7. If Unit or CA/Agreement, Name and/or No	
1. Type of Well ☐ ☐ Gas Well ☐ ☐ Oth	8. Well Name and No.	
2. Name of Operator RIDGEWAY ARIZONA OIL CROP		TLK 22 FEDERAL #5 9. API Well No.
3a. Address 777 N. ELDRIDGE PRKWY #150, HOUSTON, TX 770	30-041-10544

Plugging Procedure TKL 22 Federal #5 API No. 30-041-10544 L-22-07S-33E 1980 FSL 660 FWL

TLK 22 Federal 5 30-041-10544 Ridgeway Arizona Oil Corp May 16, 2016 Conditions of Approval

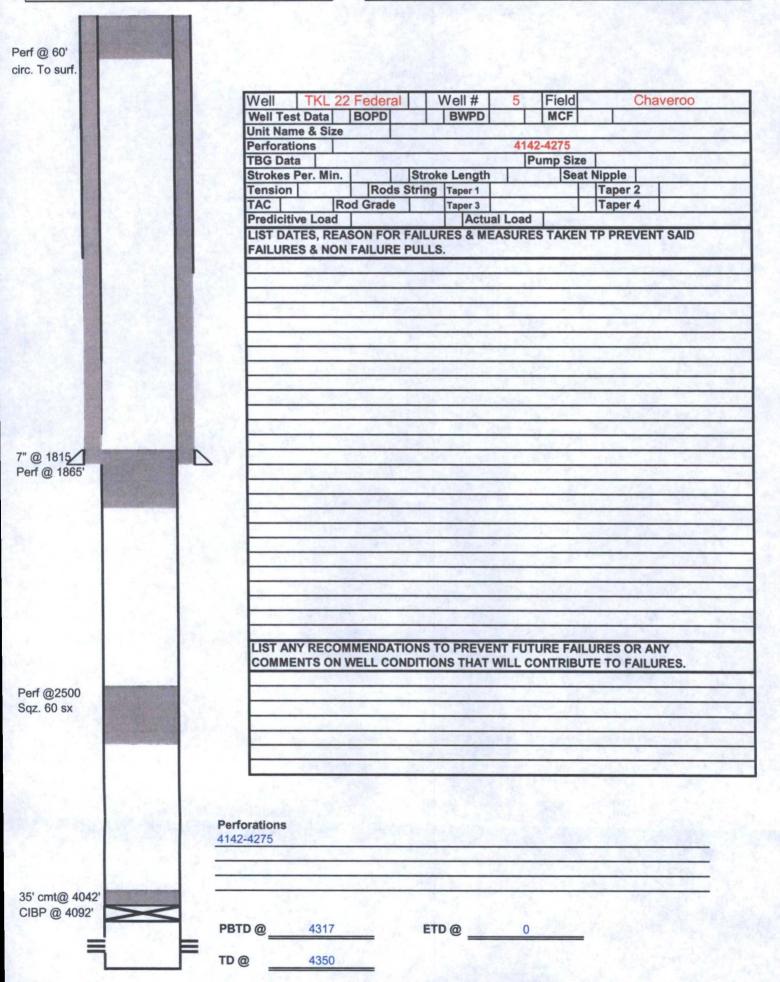
* additional plus 2300-2175 to seal yates Formation.

- 1. Operator shall place CIBP at 4,092' (50'-100' above top most perf) and place 35' of Class C cement on top as proposed. WOC and TAG.
- 2. Operator shall perf and squeeze at 2,500'as proposed tagging plug at 2,300'.
- 3. Operator shall place a balanced Class C cement plug from 2,300'-2,175' to seal the top of the Yates formation. WOC and TAG.
- 4. Operator shall perf and squeeze at 1,865' as proposed tagging plug at 1,765' to seal the surface shoe.
- 5. Operator shall place a balanced Class C cement plug from 60'- surface as proposed
- 6. See Attached for general plugging stipulations.
